From: Mary Whitesides <mary@dancindeerdesign.com>
Sent: Wednesday, July 13, 2016 8:17 AM
To: Treasure Comments
Cc: Brian Van Hecke
Subject: Treasure Hill Density
Attachments: 1985 layout2004layout (dragged).pdf; ATT00001.htm; 1985 layout2004layout (dragged) 1.pdf; ATT00002.htm

Treasure Hill Density Issue

1985 / 86 Approved Site Plan, Footprints and Density
 Buildings work with the natural grade – No excavated hillsides
 Only Two entrances from Lowell / Empire

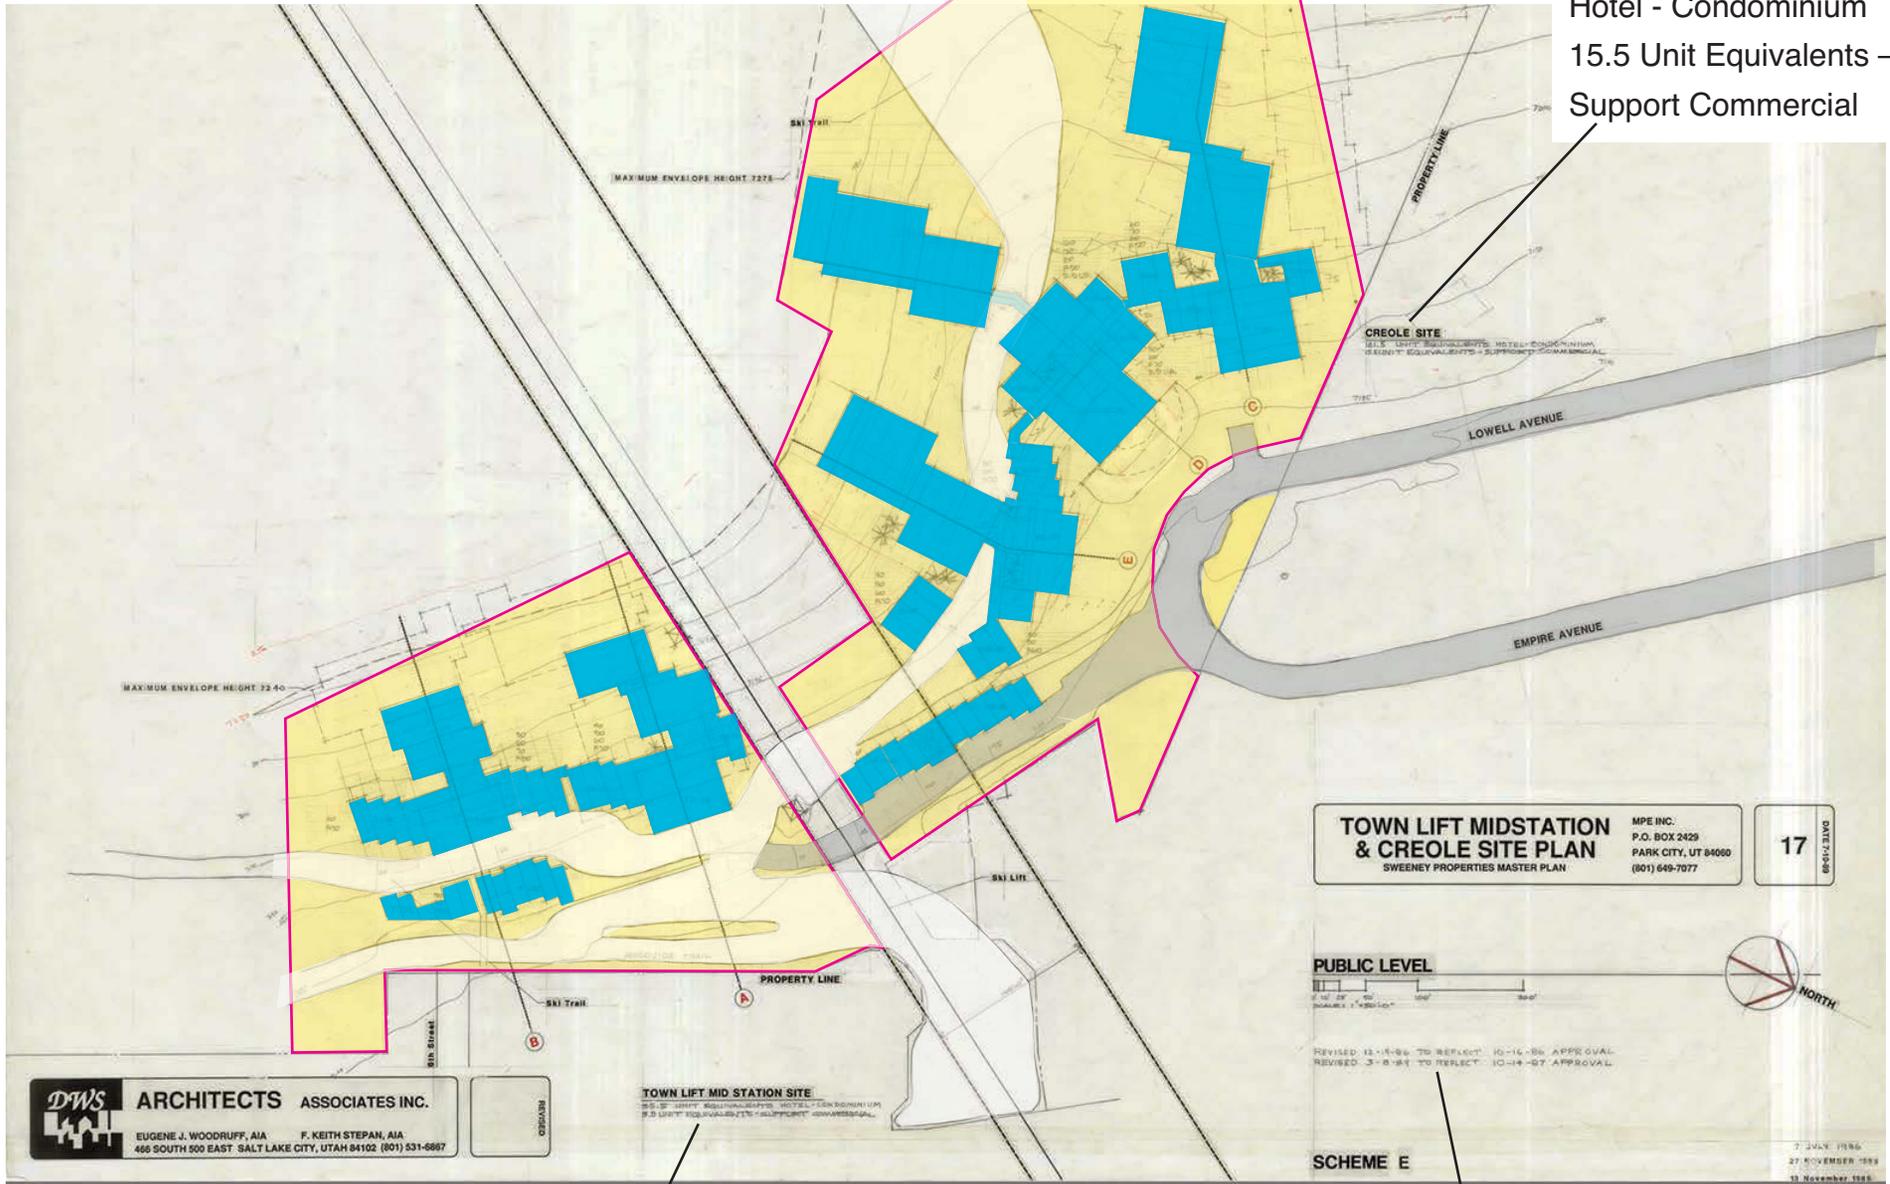
2004 Expanded Project — More than twice the approved square footage
Massive hillside Excavations, mostly outside the MPD boundaries
Four entrances from Lowell / Empire

Hillside Excavations

Buidings underground
